CITY OF LACONIA
REGULAR PLANNING BOARD MEETING
Tuesday, January 6, 2026 - 6:30 PM
City Hall - Armand A. Bolduc City Council Chamber

6.1. PB2026-021; 604 Endicott St N (128-252-3.1)

Applicant proposes to amend their previous site plan approval to increase the size and capacity of the stormwater detention pond.

Re: Objection to Proposed Site Plan -- PB2026-021; 604 Endicott St N

Figure 1: Route 3 Flow

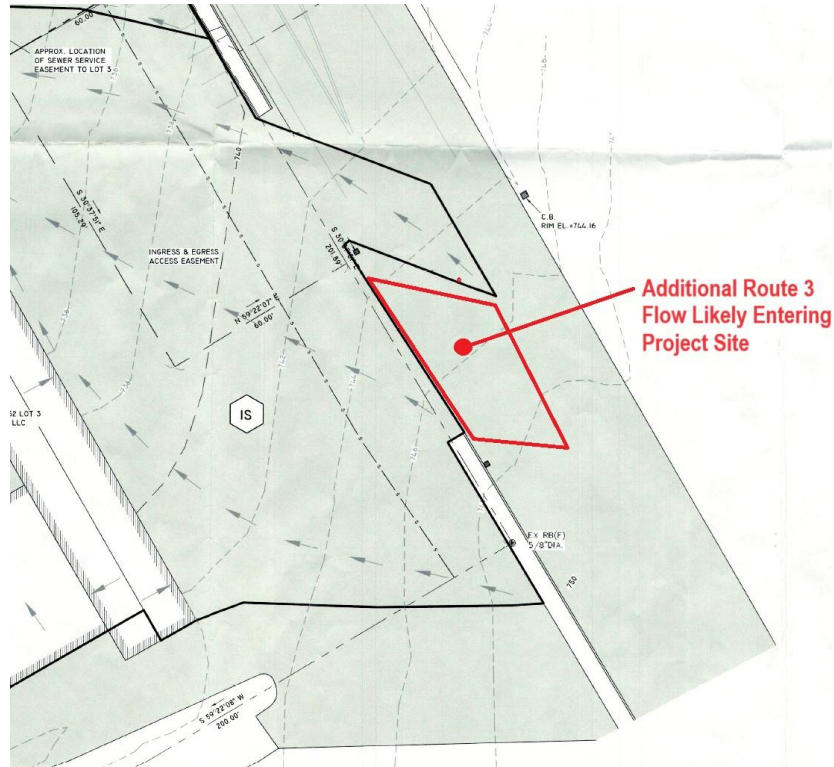
1. As stated previously, the hydrologic model appears to underestimate the area of Route 3 flowing onto 604 Endicott St N. No additional area was added to the revised stormwater calculations to account for this flow from Route 3. The existing and proposed flows onto 554 Endicott St N are likely slightly underestimated by the model. See Figure 1 and Figure 2 on the following page:

Figure 3: Rear Gravel (Existing Conditions Plan)

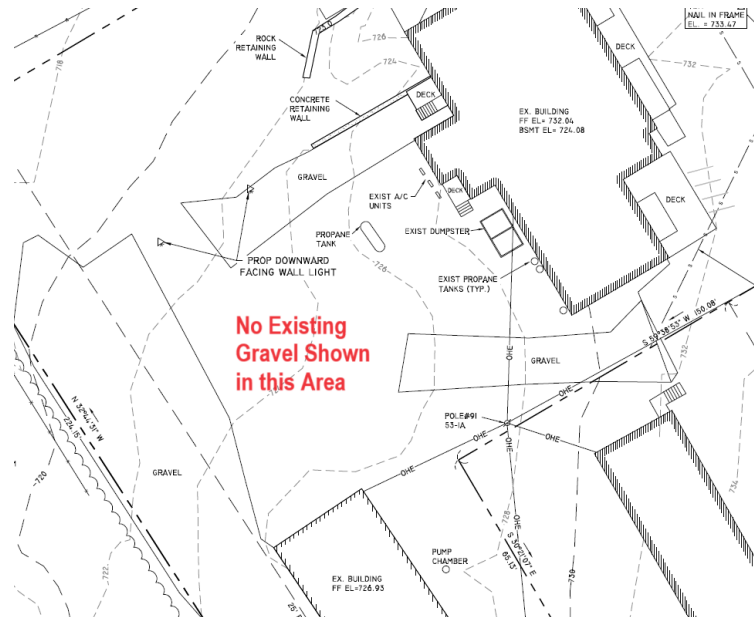
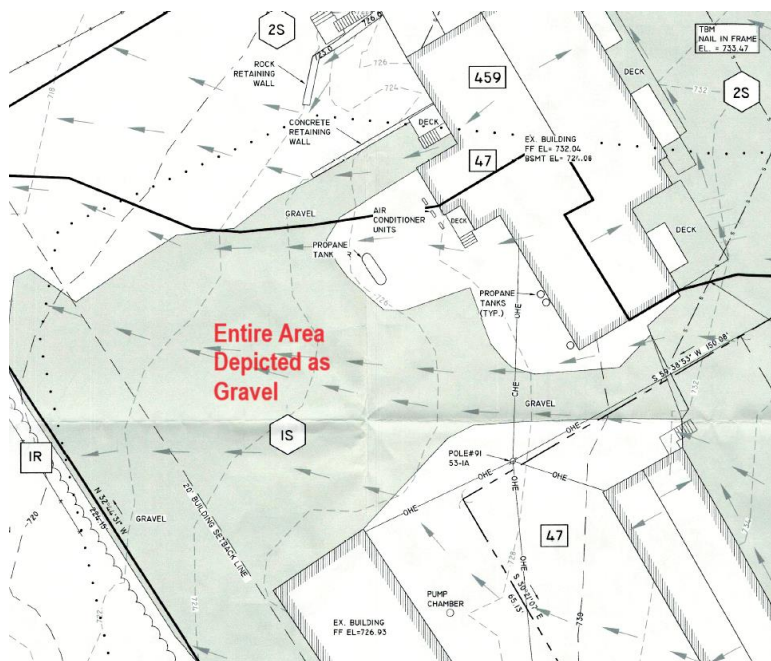
2. As stated previously, the Pre-Condition map depicts approximately 4,000 sq ft of existing gravel area that is not depicted on the Existing Conditions plan. This area was not added to the pre-development drainage model. If this gravel area does not exist then the model likely calculates the existing flows to be higher than they actually are. This, in turn, may result in proposed flows that are higher than the actual existing flows.

Figure 1: Route 3 Flow

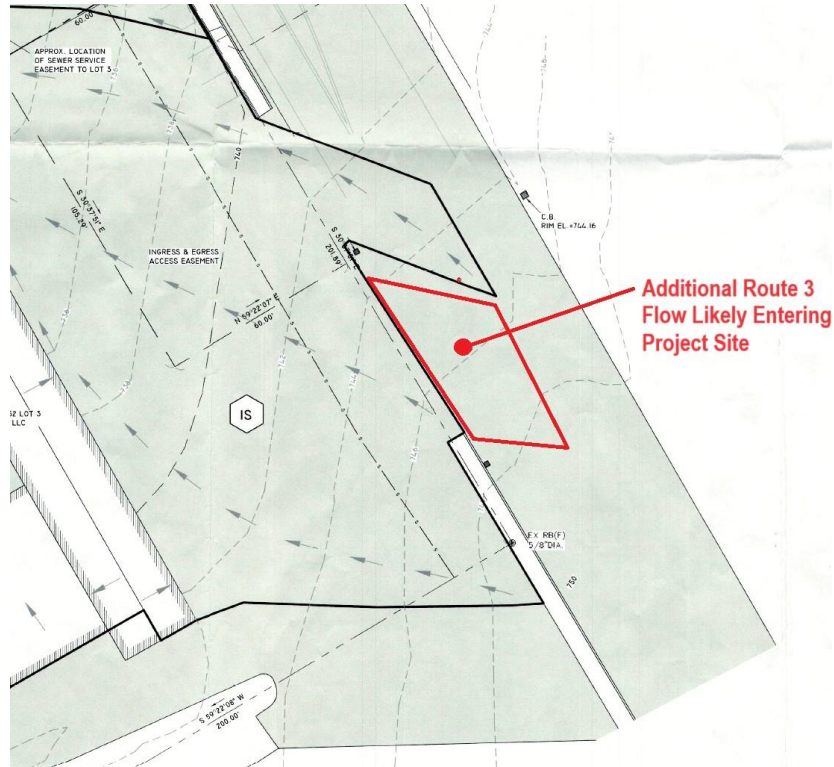
1. As stated previously, the hydrologic model appears to underestimate the area of Route 3 flowing onto 604 Endicott St N. No additional area was added to the revised stormwater calculations to account for this flow from Route 3. The existing and proposed flows onto 554 Endicott St N are likely slightly underestimated by the model. See Figure 1 and Figure 2 on the following page:

Figure 3: Rear Gravel (Existing Conditions Plan)

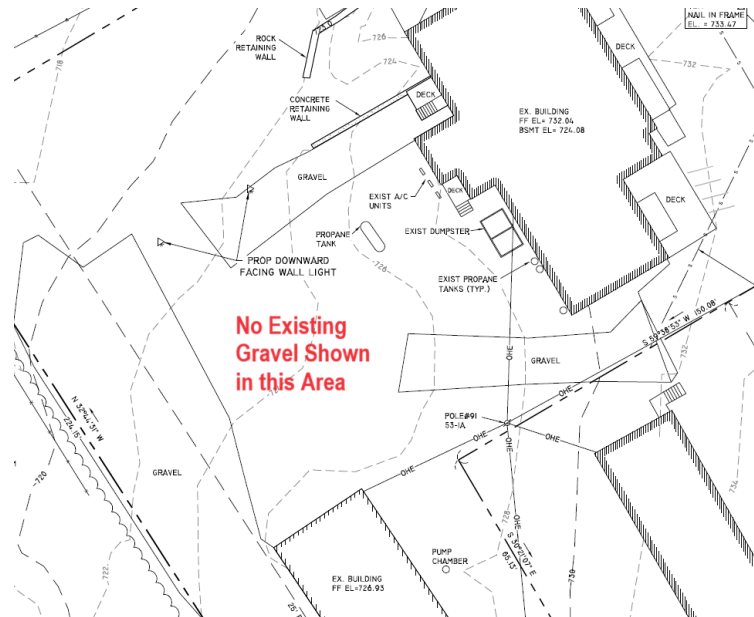
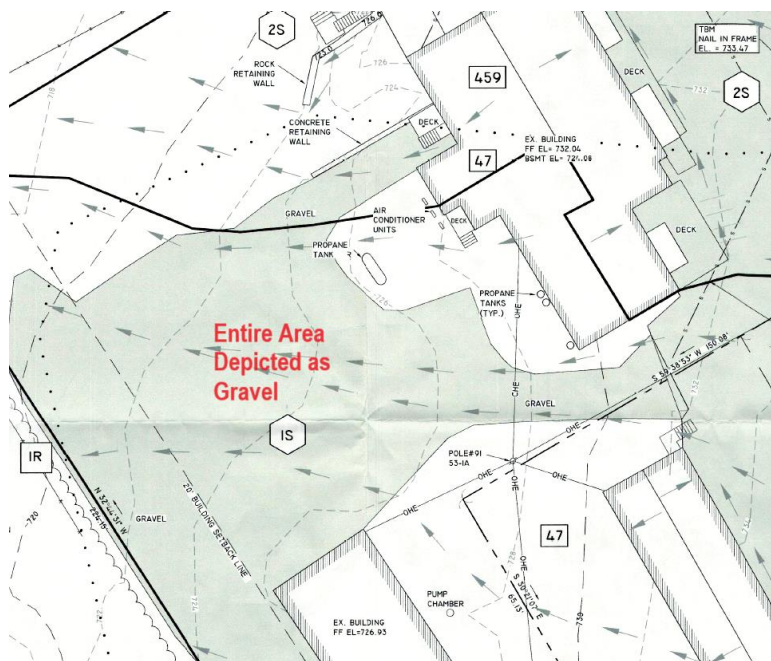
2. As stated previously, the Pre-Condition map depicts approximately 4,000 sq ft of existing gravel area that is not depicted on the Existing Conditions plan. This area was not added to the pre-development drainage model. If this gravel area does not exist then the model likely calculates the existing flows to be higher than they actually are. This, in turn, may result in proposed flows that are higher than the actual existing flows.
